**Request for Additional Information No. 378(4409, 4513, 4490), Revision 2
Supplement 3**

U. S. EPR Standard Design Certification

Docket No. 52-020

**QUESTIONS for Containment and Ventilation Branch 1 (AP1000/EPR Projects)
(SPCV)**

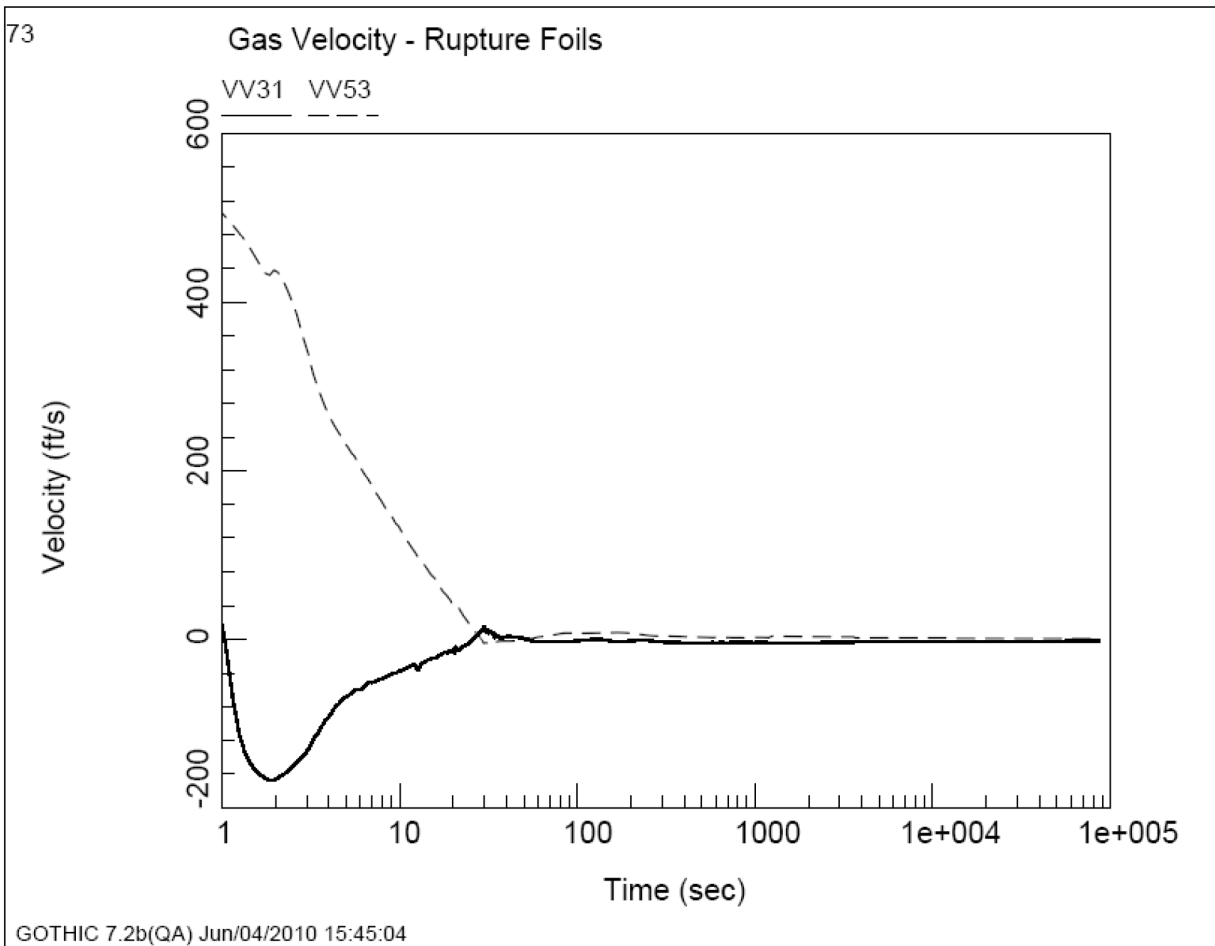
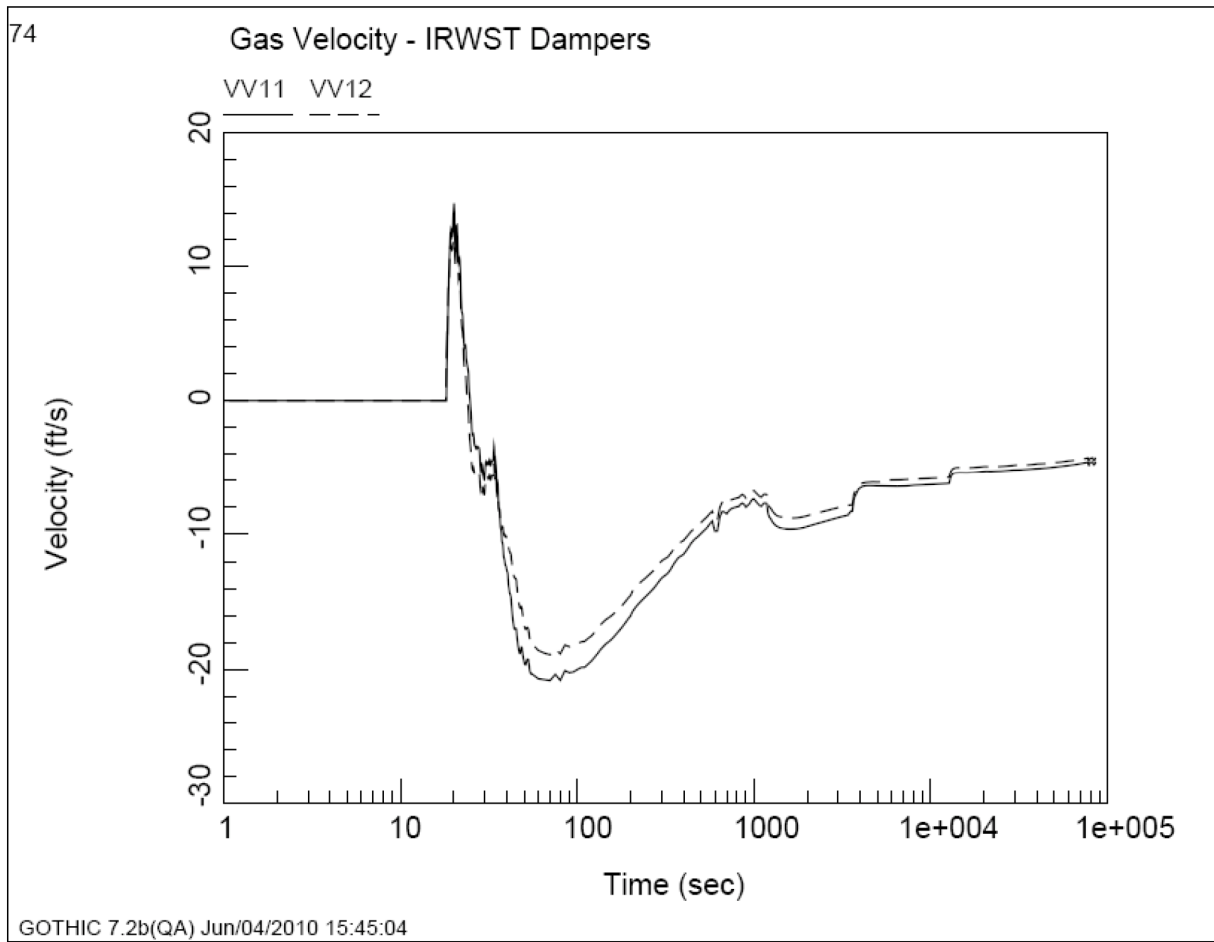
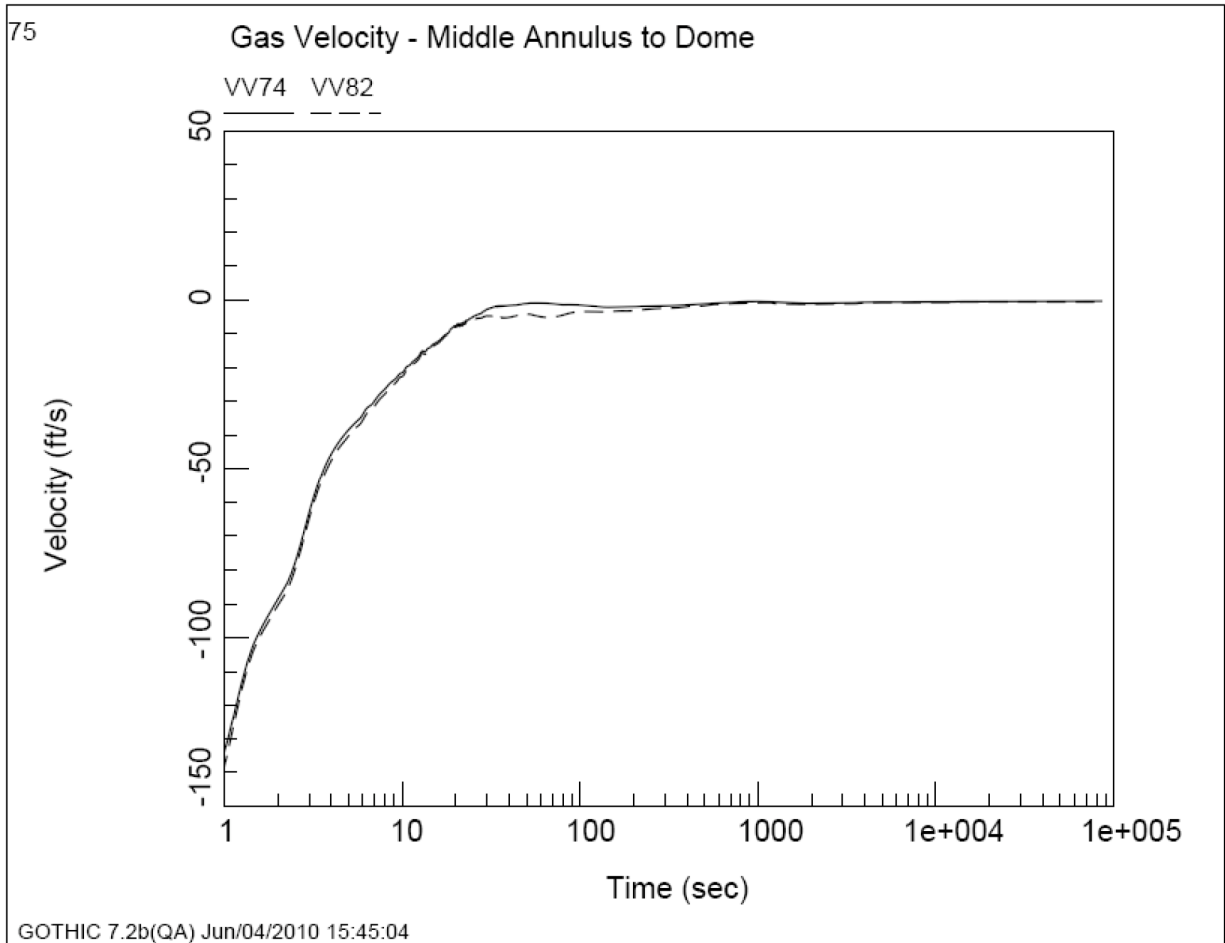
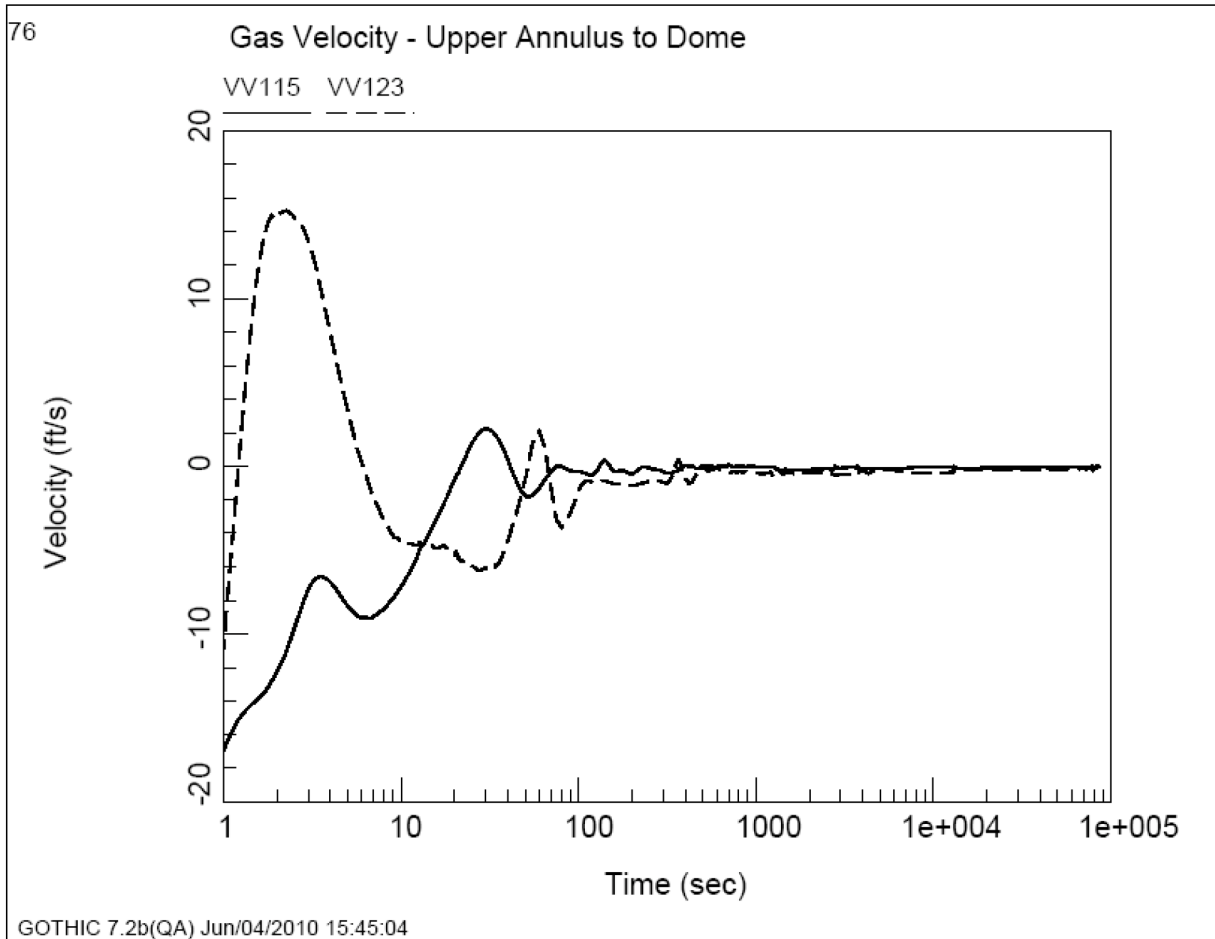
- a. Location of the maximum temperature reported in the FSAR (elevation and sub- divided node or lumped parameter node).
- b. Time history plots for atmospheric temperatures in the sub-divided dome (at elevations along the containment centerline, (19 elevations). Use the same time scale as the FSAR.
- c. Time history plots for atmospheric temperature below the dome (lump parameter nodes 1-30, excluding sub-divided dome region). Use the same time scale as the FSAR.
- d. Time history plots for gas velocity in pathways (FP #31 and 53 – rupture foils; FP# 11 and 12 – IRWST dampers; FP# 74 and 82 – middle annulus to dome; FP# 115 and 123 – upper annulus to dome). Use the same time scale as the FSAR.

- a) The temperature reported in U.S. EPR FSAR Tier 2, Figure 6.2.1-17 is the vapor temperature in the room that contains the break (equipment room – lumped parameter node #10).
- b) Figure 06.02.01-88-1 through Figure 06.02.01-88-4 show the time history atmospheric temperature for the sub-divided dome region. The temperatures are taken along the containment centerline. The plots are divided based on elevation, with Level 1 at the bottom of the dome and Level 19 at the top.
- c) Figure 06.02.01-88-5 through Figure 06.02.01-88-10 show the time history atmospheric temperature for volumes below the dome region (lumped parameter nodes one through 30, excluding the sub-divided node region).
- d) Figure 06.02.01-88-11 through Figure 06.02.01-88-14 show the time history gas velocity for the requested pathways.

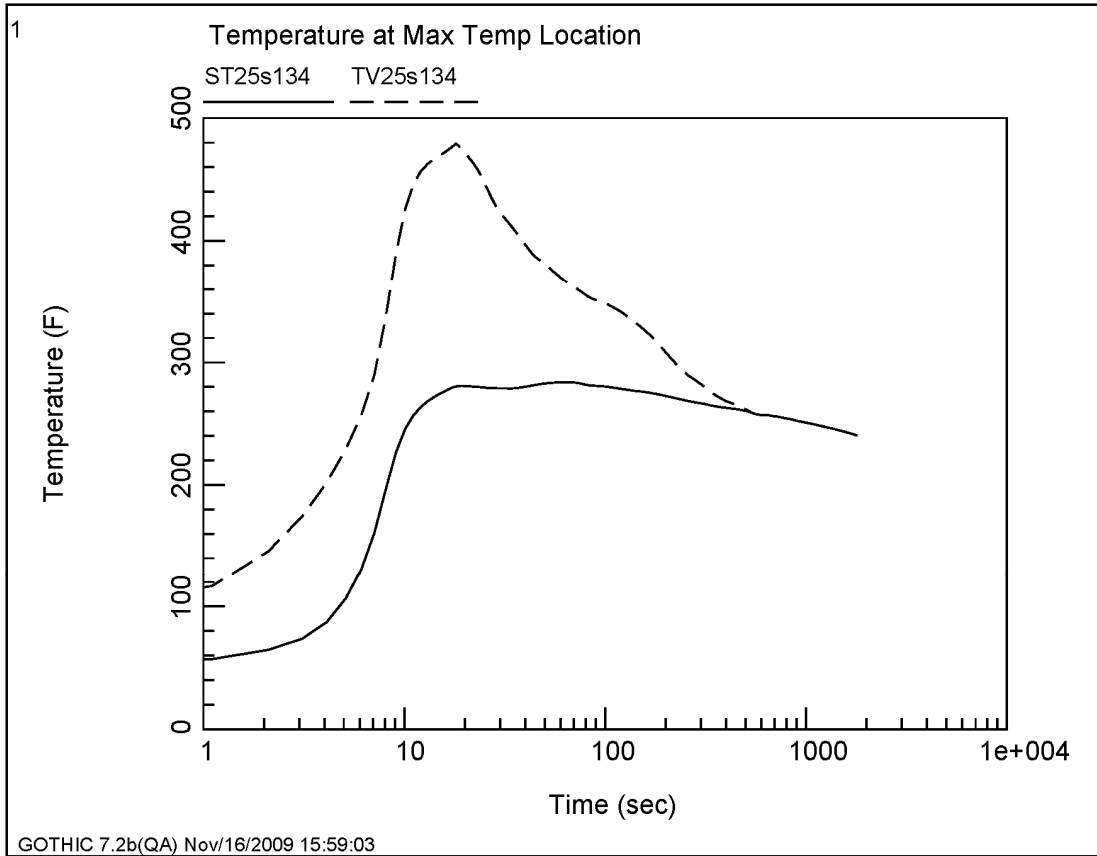
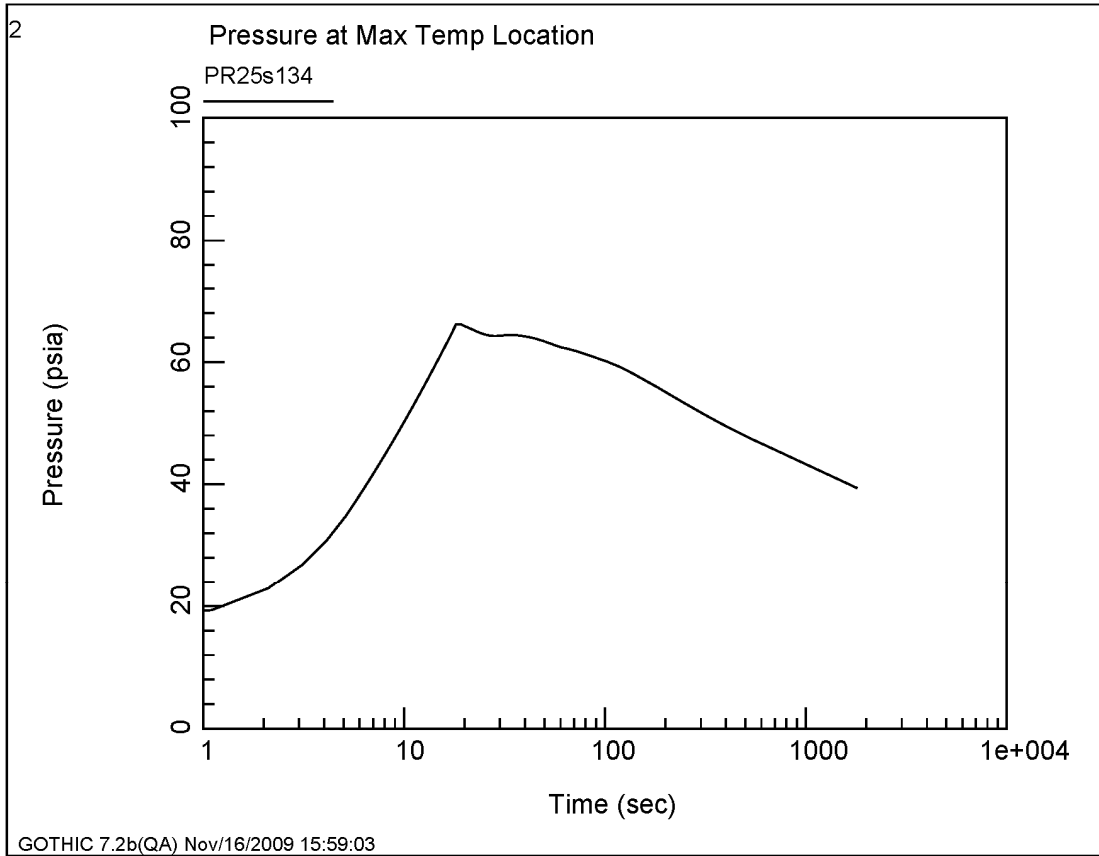
- c. Time history plots for maximum atmospheric temperature location and pressure. The atmospheric temperature plot should include both gas (vapor) and saturation temperatures.

- b) The maximum atmospheric temperature occurs in the containment dome in the subdivided cell 134 of Volume 25. Cell 134 of Volume 25 has an elevation of +98.59 feet.

- c) The time history plots for maximum atmospheric temperature location and pressure are given in Figures 06.02.01-89-1 and 06.02.01-89-2.
- d) The time history atmospheric temperature plots for the lumped parameter nodes below the dome (nodes one through 30, excluding node 25) are given in Figures 06.02.01-89-3 through 06.02.01-89-18.
